Oakton College District 535

Invitation to Bid # 0925-24-03 -Addendum #1
Issue Date: September 25, 2024

Oakton College Des Plaines Adjacencies Renovations - Phase 1

2.) Provide the updated drawing and Project Manual, including responses to the questions submitted by vendors.

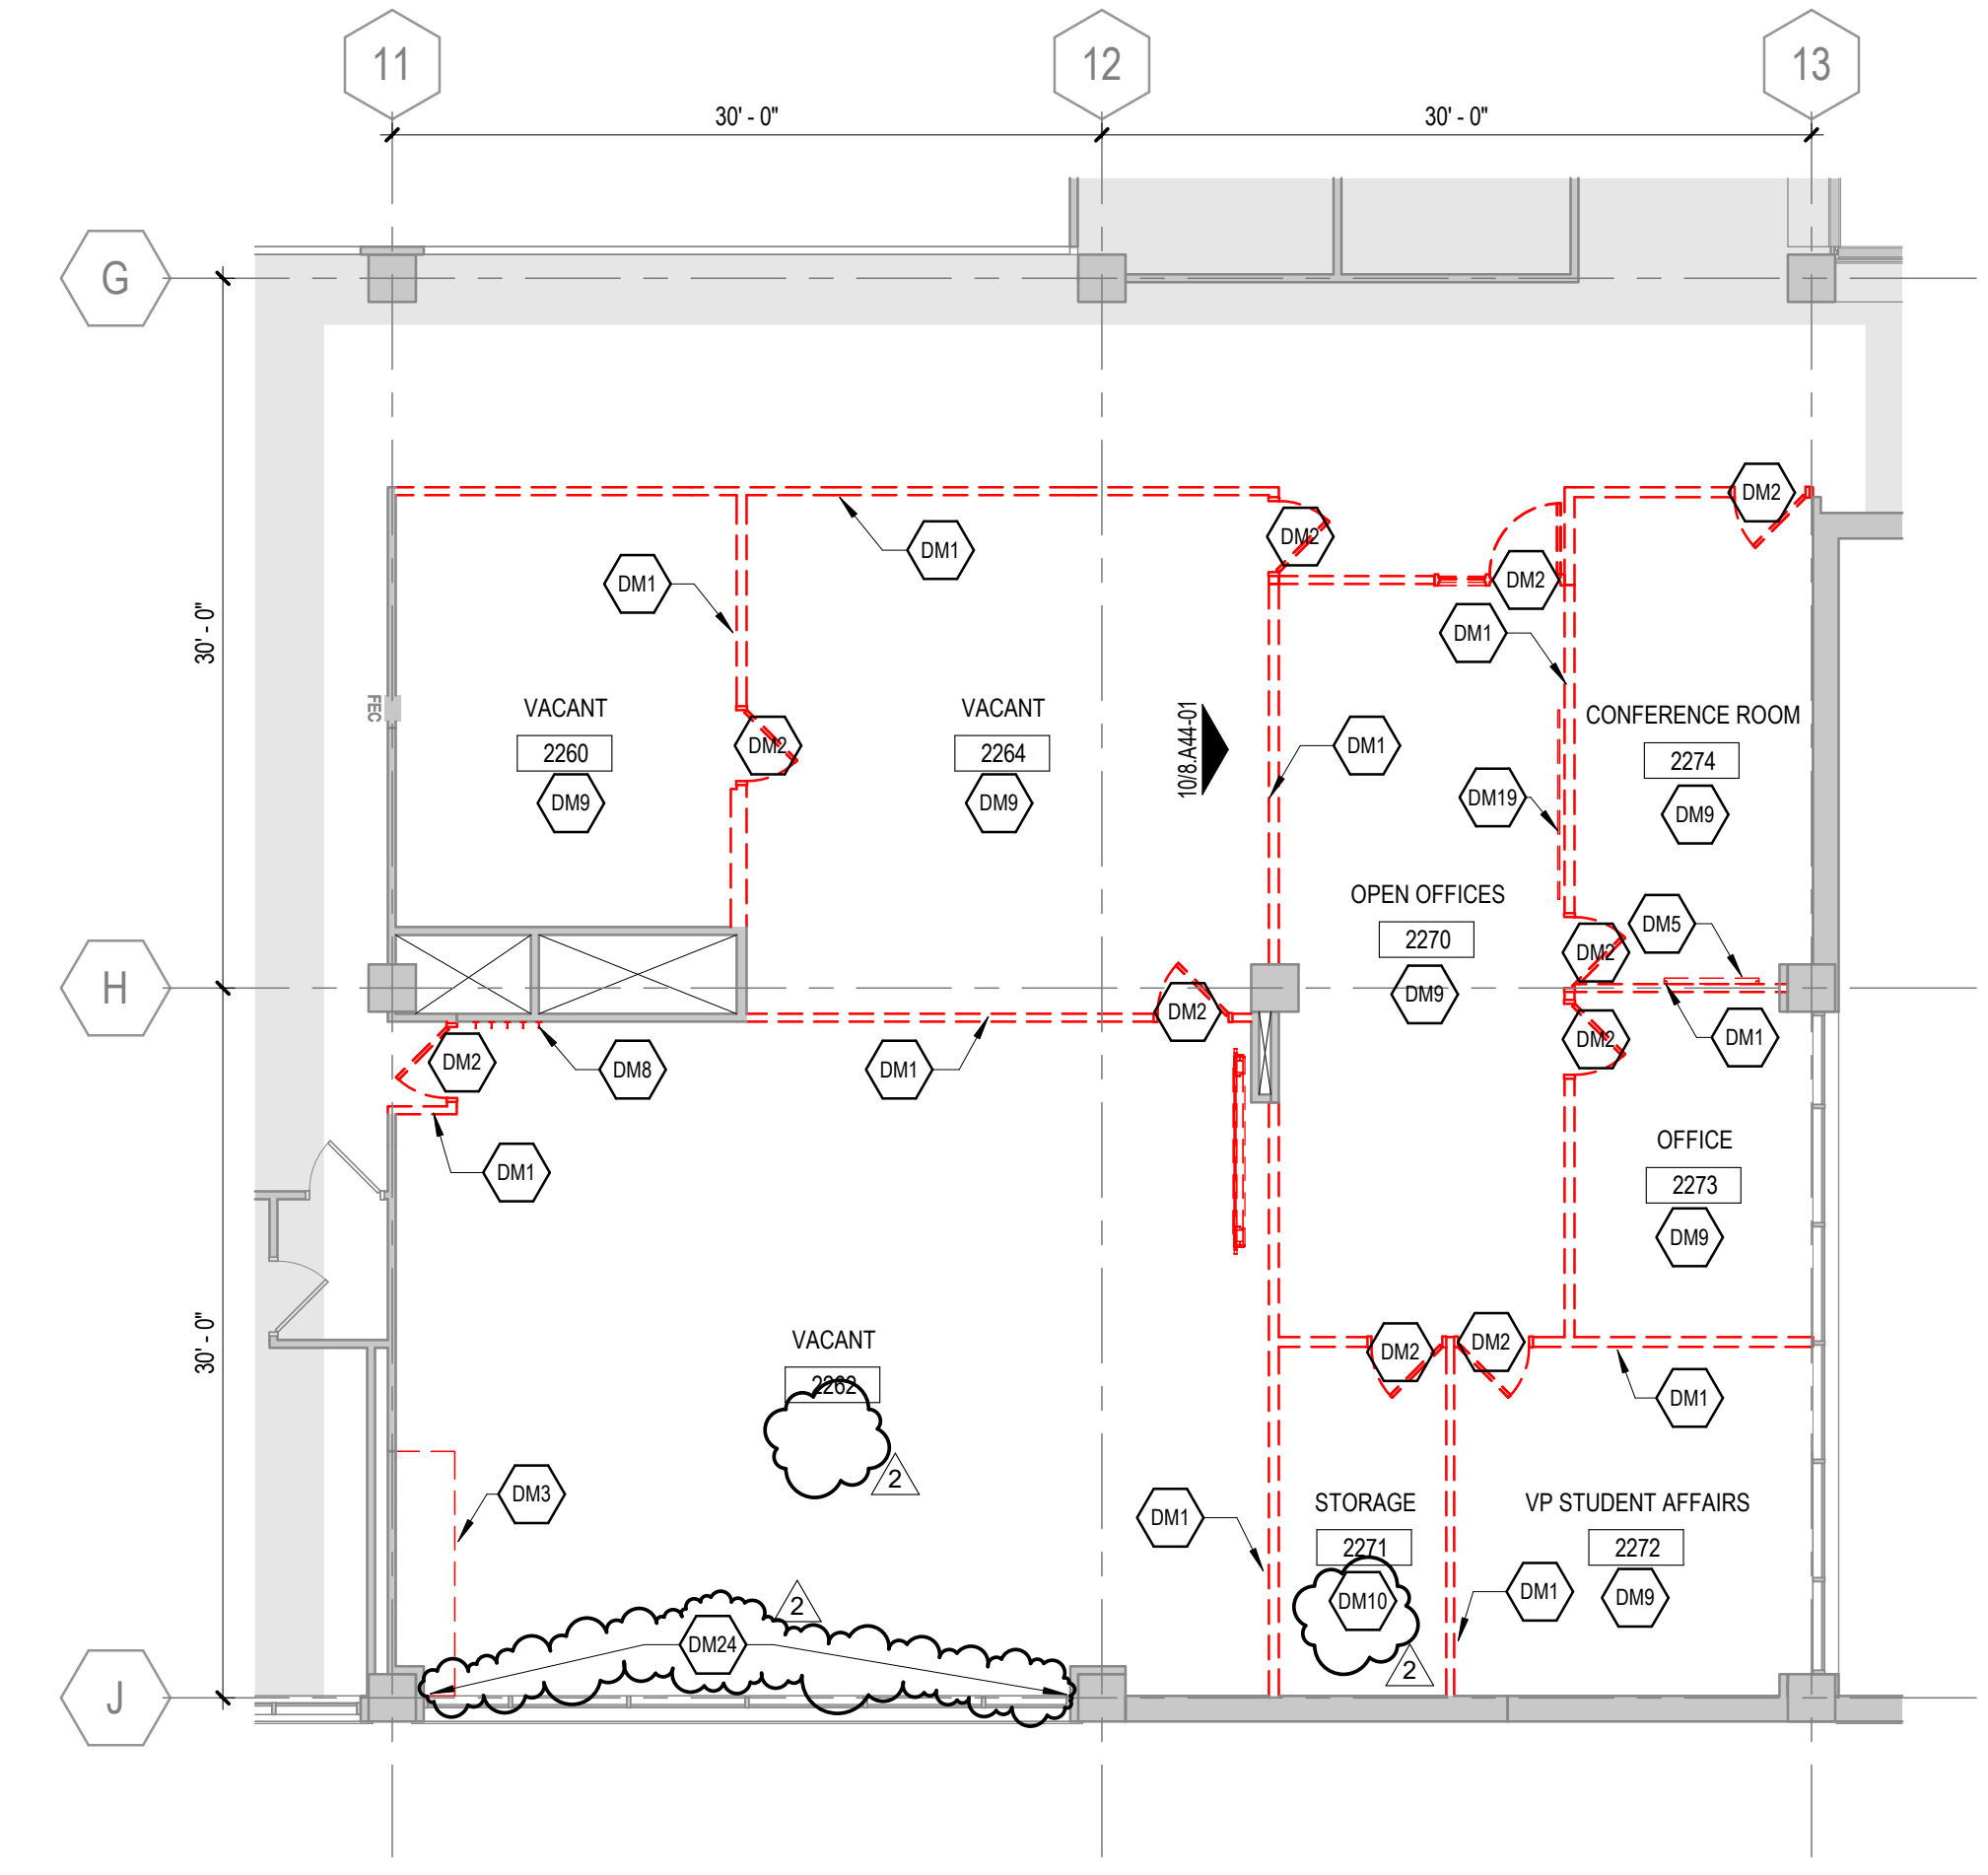
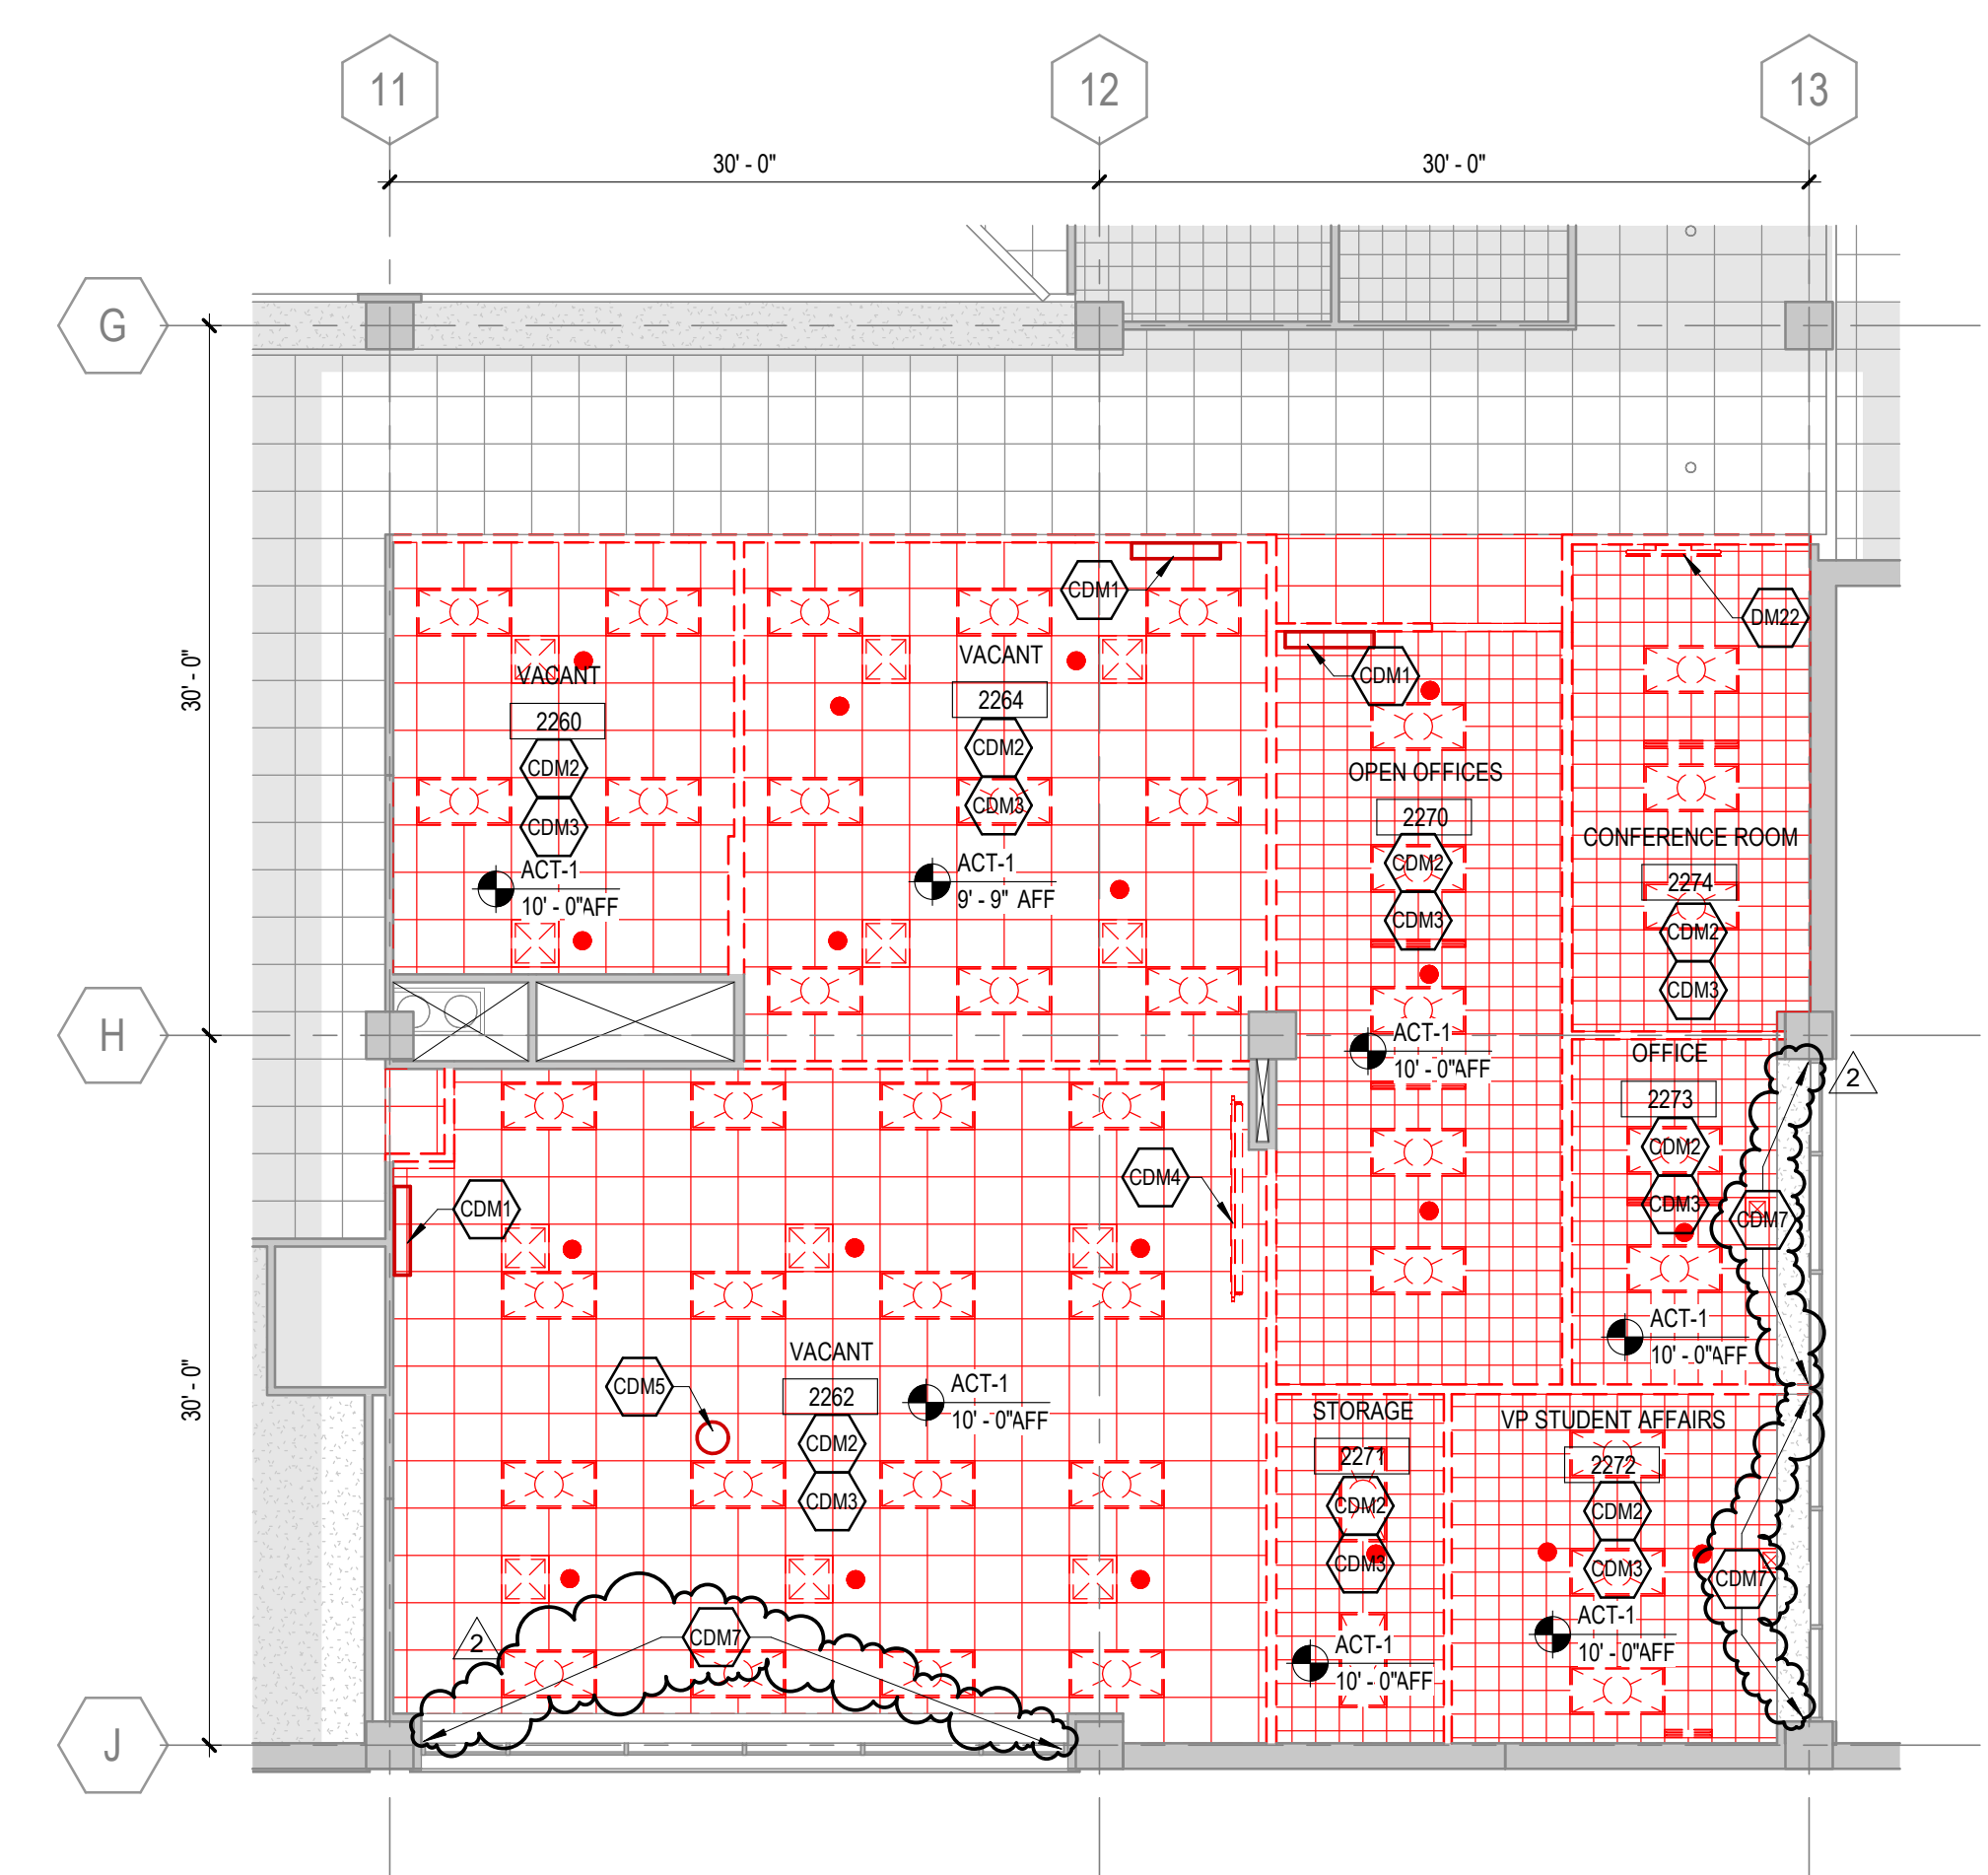
1. General:
 - a. G00-00 Cover: Sheet Index Updated
2. Architectural:
 - a. Sheet .8 A04-01 Demolition Plans
 - 1) Added new RCP demolition keynote regarding window treatments

- 2) Added new demolition keynotes regarding wall protection
 - 3) Added new demolition keynote regarding wall demolition
 - 4) Revised DM4 at Computer Lab entrance

- 5) Revised floor demolition keynotes
 - b. Sheet .8 A11-01 Floor Plans & Floor Details
 - 1) Added wall furring at window
 - c. Sheet .8 A12-01 Reflected Ceiling Plans

15. On drawing A04-01 in room 2262 there is some sort of epoxy paint for flooring in lieu of carpet. Please clarify if that is to be removed.

16. Are any of the window shades to be removed on the existing windows? There are not called to be removed and drawing A12-01 is calling for new window treatments. Please clarify.

21. On drawing A04-01 in room 1833 there is an existing wall protection chair rail, but it is not called to be removed. Is it to be removed and what wall patching is required after it is removed? Please clarify.

A: See revised sheet A04-01.

A: See revised demolition RCP on A04-01.

A: See revised sheet 8.A04-01 Demolition Plans.
